PREVOST

WARRANTY BULLETIN

Wb11-20

DATE : MAY 2011	SECTION : 18 - Body
EXPIRATION: MAY 2013	
SUBJECT : BELT ROUTING DECAL, OIL SPECIFICATION, COOLANT SPECIFICATION AND FUEL TANK SPECIFICATION DECALS

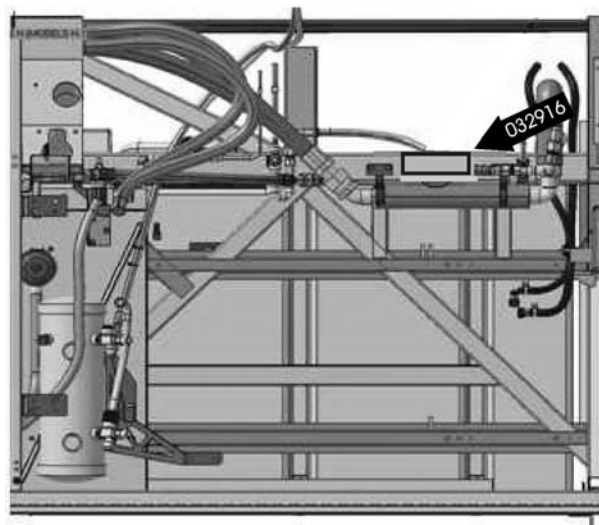
1. The fuel tank specification decal #032916 must be clearly visible in the condenser compartment. Affix this decal in the condenser compartment at the location shown on picture.

WITHOUT WHEELCHAIR LIFT ►

WITH WHEELCHAIR LIFT ►

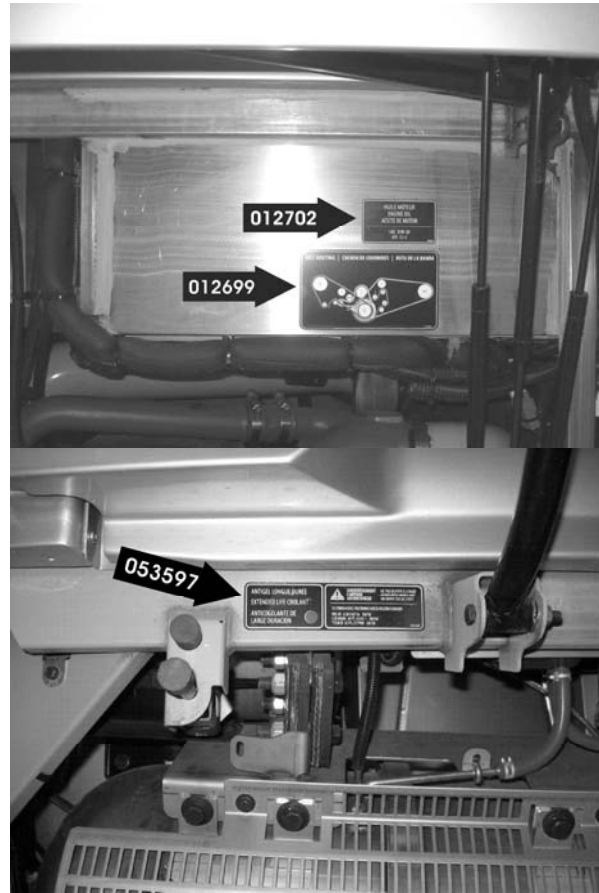
2. Affix new belt routing decal #012699 at the upper right section of engine compartment as shown on picture, replacing former decal #019095. Do not leave decal #019095 in the engine compartment if it remains visible.
3. Affix new oil specification decal #012702 as shown on picture, replacing former decal #012399(eng/fr) or #012400 (eng/esp). Do not leave the existing decal in the engine compartment if it remains visible.
4. Affix new coolant specification decal #053597 as shown on picture, replacing former decal #053487(eng/fr) or #053488(eng/esp). Do not leave the existing decal in the engine compartment if it remains visible.
